Appendix A

Field Change Requests

**NW Natural Pre-Remedial Design Data Gaps Sampling
US Moorings Project Area – Fall 2020
Field Change Request Form**

Field Change Request (FCR) Title: Subsurface Sediment Sampling Intervals for Alkylated PAH and TPH Analyses

Figure 1
Revised Proposed Angled Top of Riverbank Boring Locations

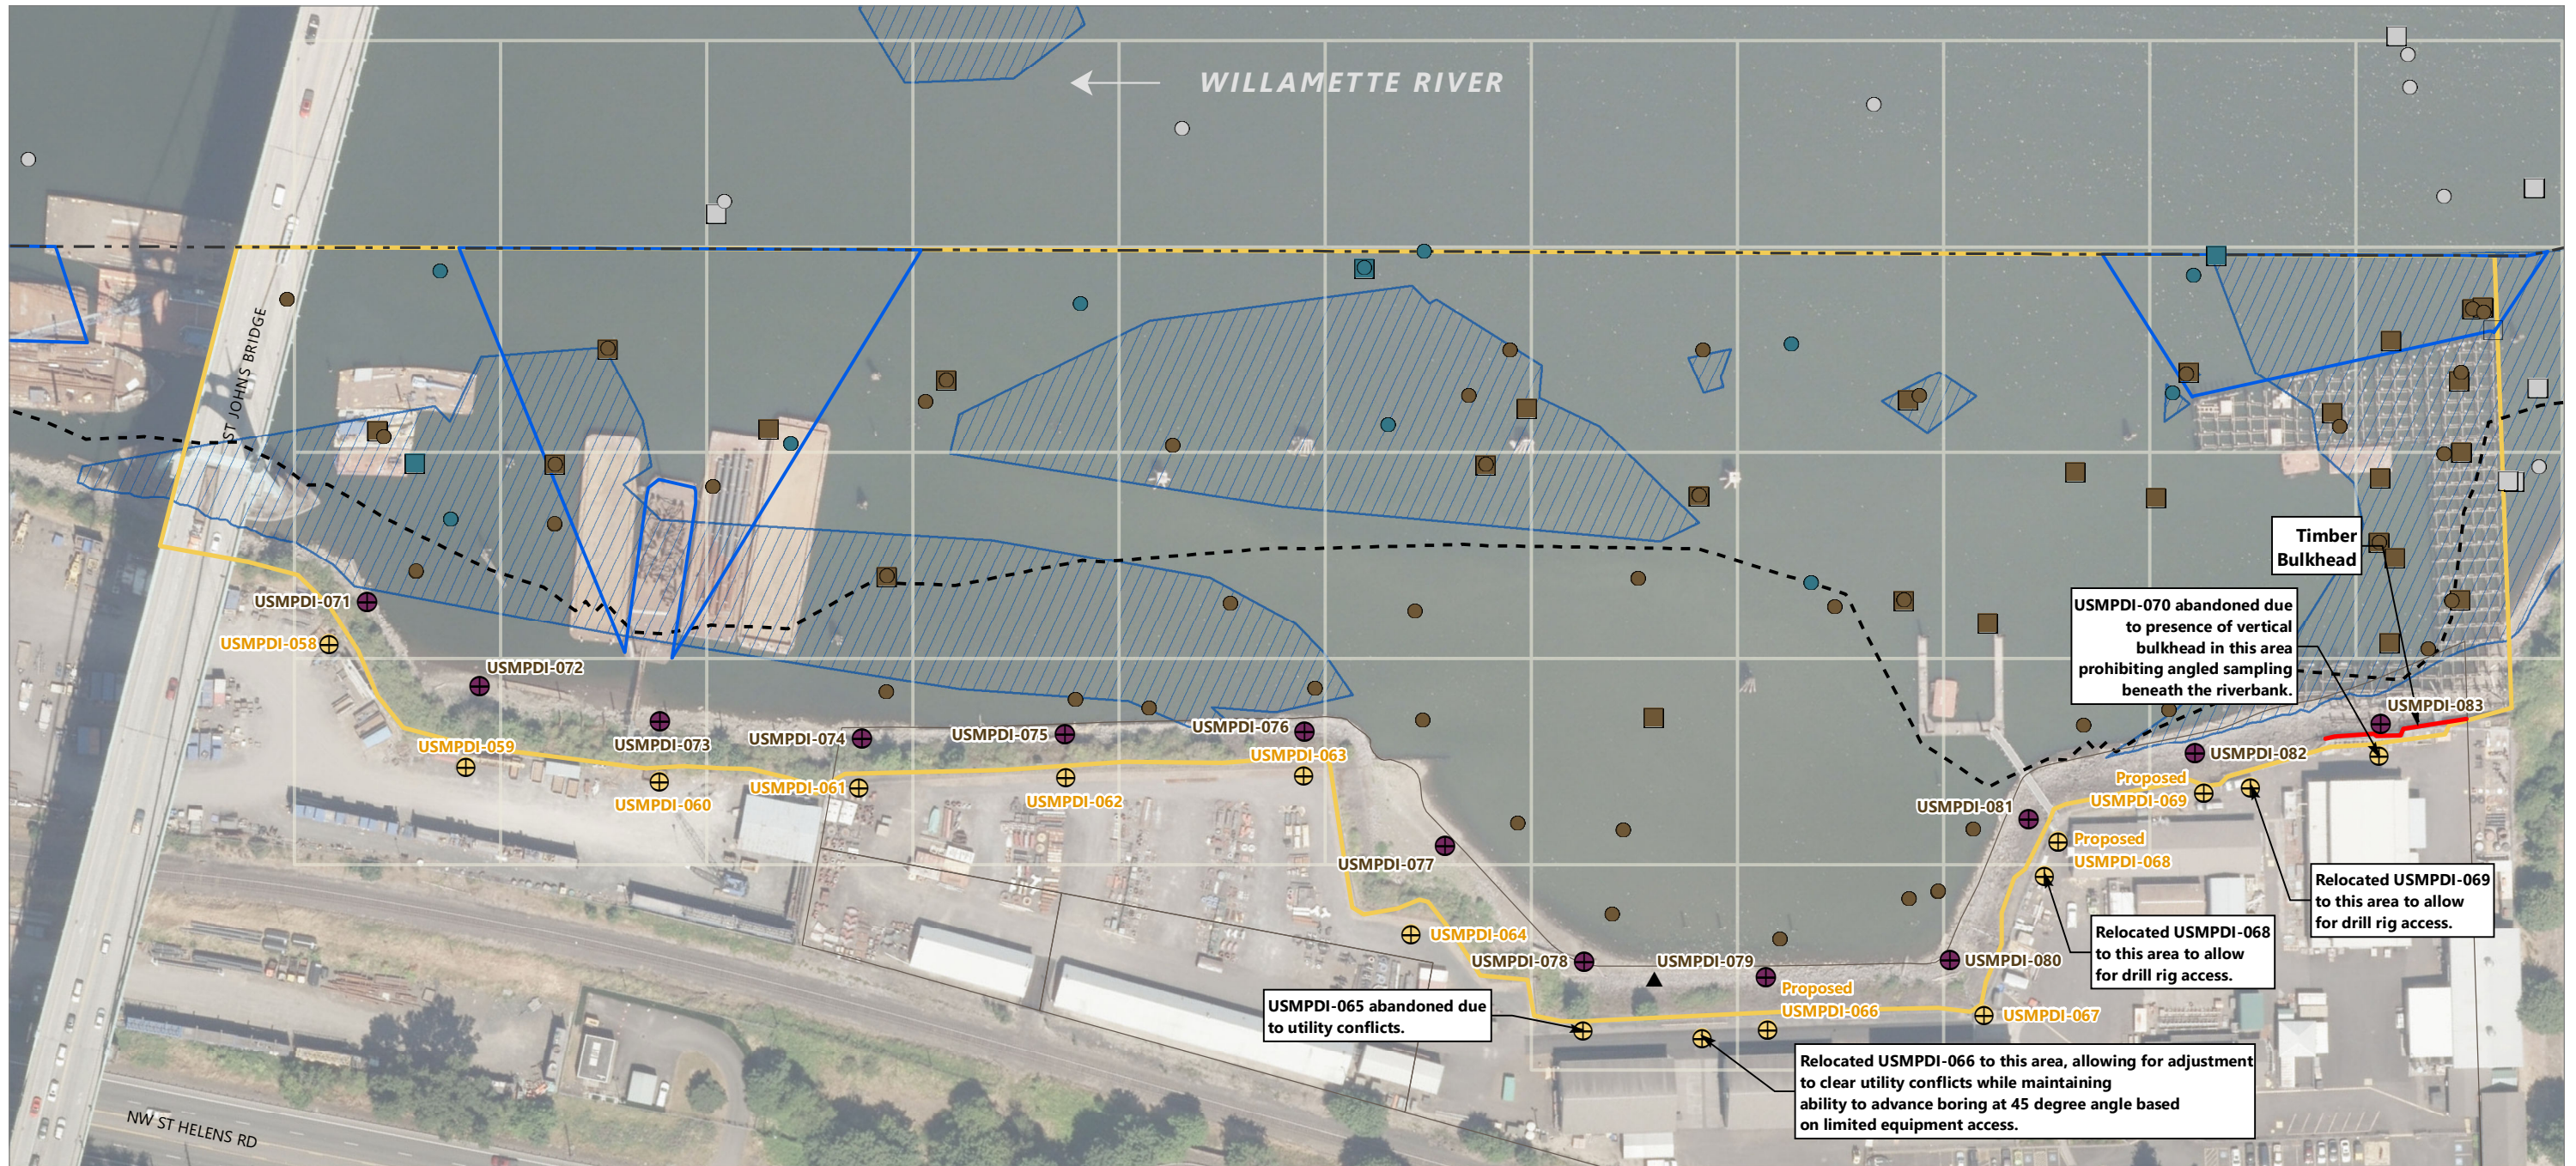
Recommended Change
<p>NW Natural proposes to abandon riverbank angled boring locations USMPDI-065 and USMPDI-070 due to the presence of utilities and timber bulkhead wall, respectively, and repositioning the locations to avoid these conflicts will result in a boring separation much closer than the proposed 150 feet and therefore unnecessary to support design. Consistent with Section 3.3.2 and Figure B3-2 of the <i>Revised Final Field Sampling Plan</i> (Appendix B to the PDIWP), NW Natural will attempt to collect three-point composite surface (0 to 1 foot below ground surface) soil samples from the face of the riverbank at locations USMPDI-078 and USMPDI-083 adjacent to the proposed abandoned riverbank angled boring locations USMPDI-065 and USMPDI-070, respectively, to characterize the riverbank soil quality in these areas. If collecting the surface samples is not feasible, NW Natural will discuss with EPA whether additional data is necessary to support remedial design.</p>

Figure 1
Revised Proposed Riverbank Surface Soil Sampling Locations

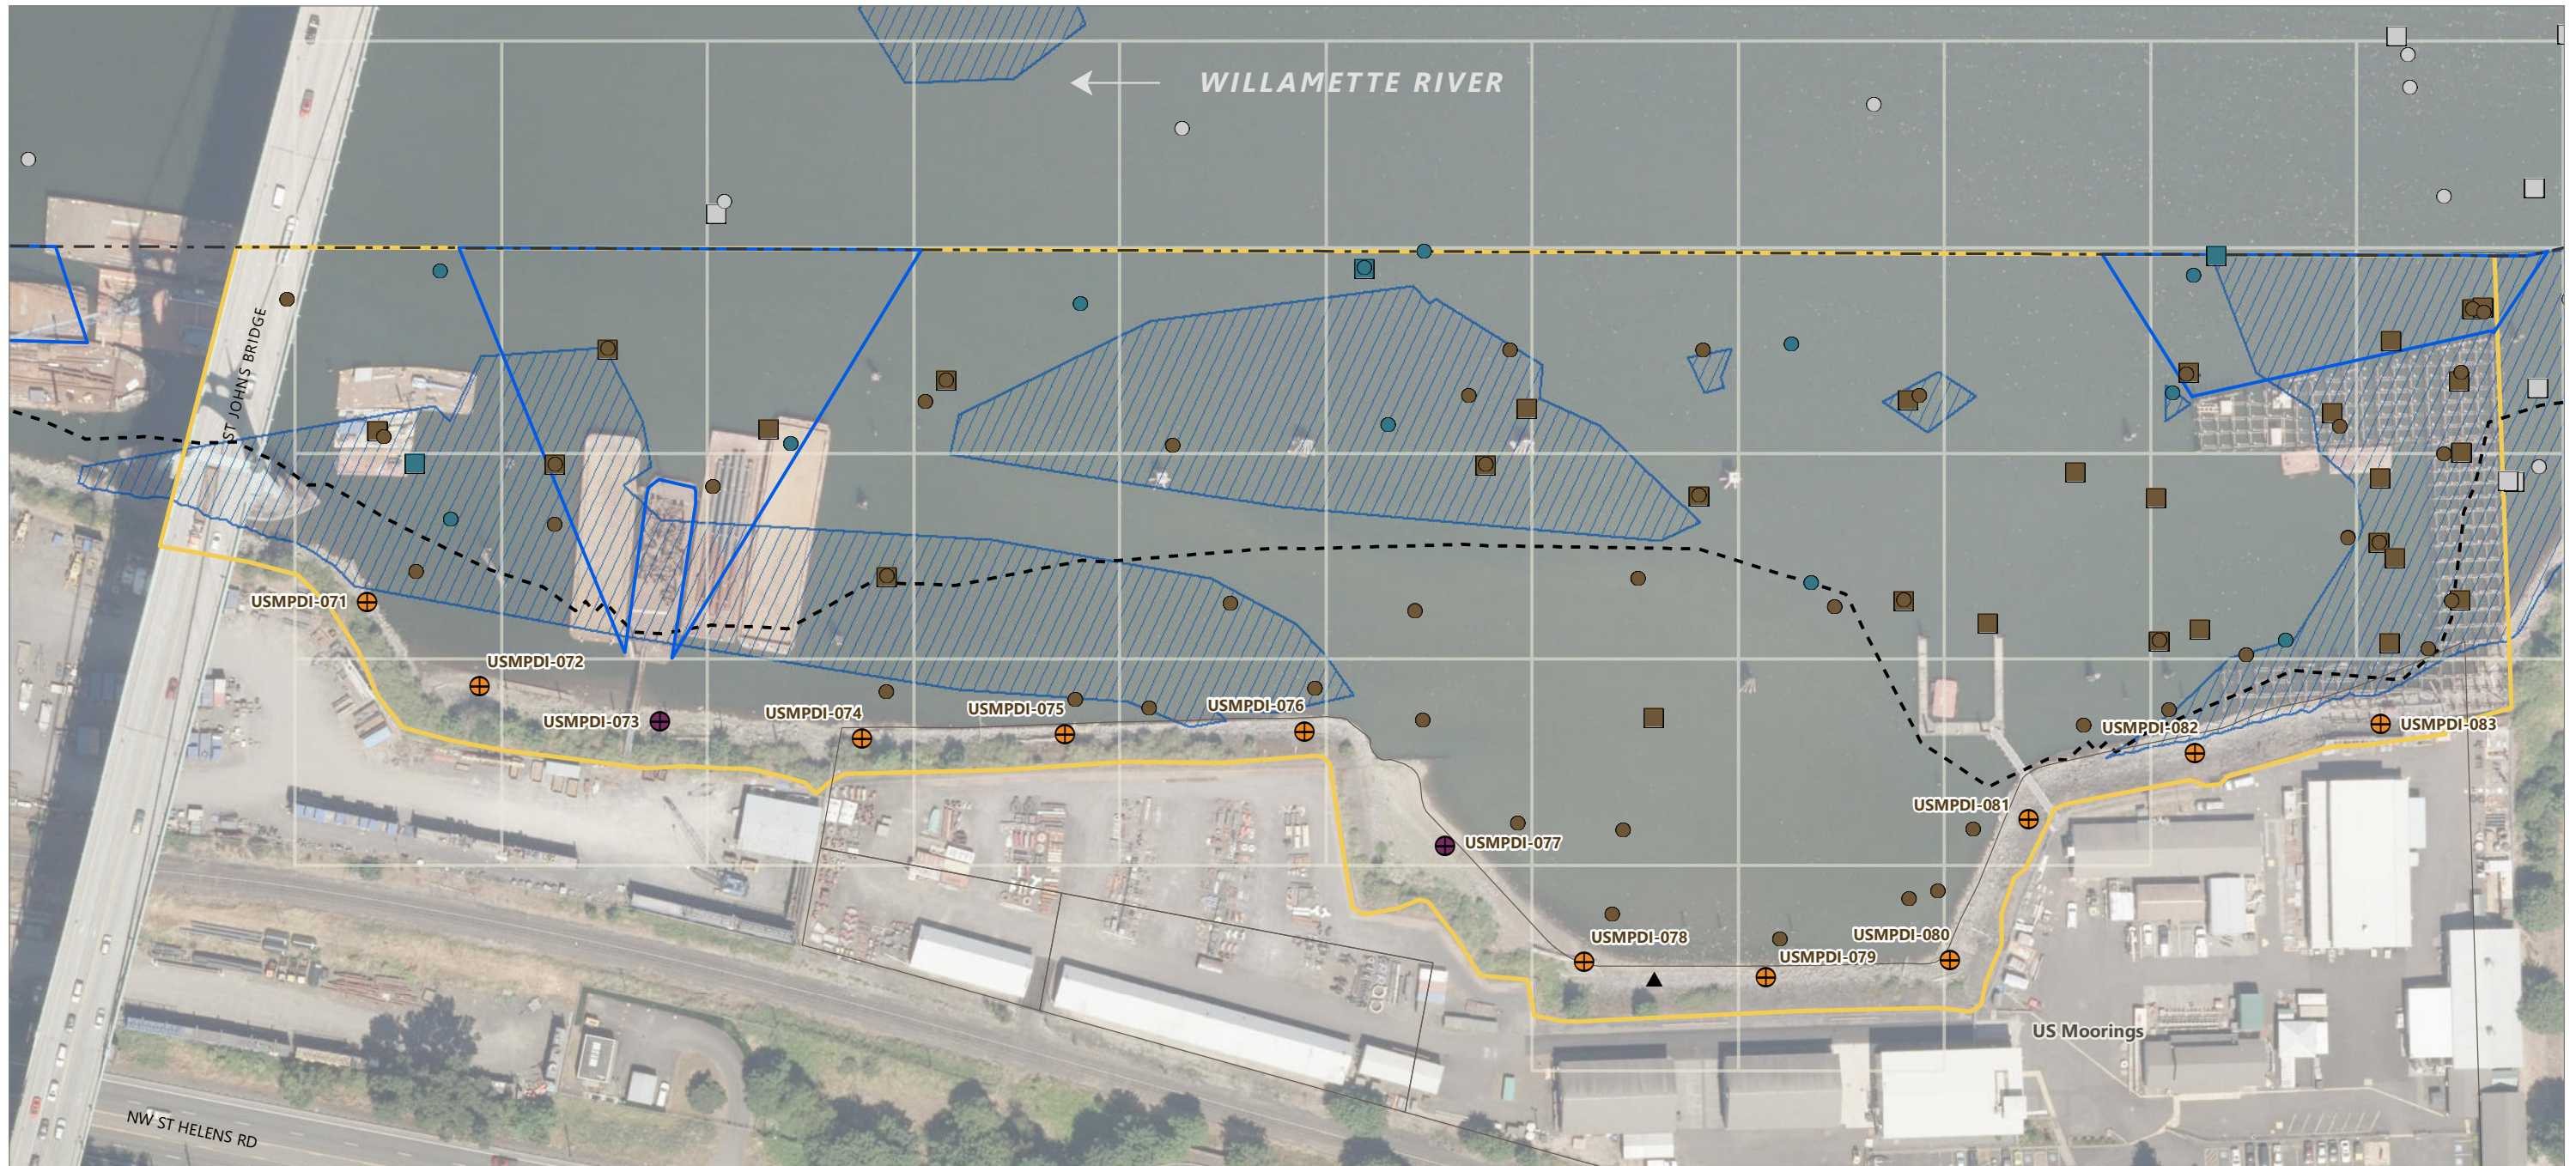
Recommended Change
<p>As verbally agreed with EPA oversight personnel during the visual reconnaissance, NW Natural proposes to abandon all riverbank surface soil locations other than USMPDI-073 and USMPDI-077 due to the lack of surface erodible soils, as photograph documented in Attachment A. In addition, due to the small area of potentially erodible solids at locations USMPDI-073 and USMPDI-077, a two-point composite grab sample was homogenized to create the sample at these locations, and the mid-point of the two samples will be used as the sampling location.</p>
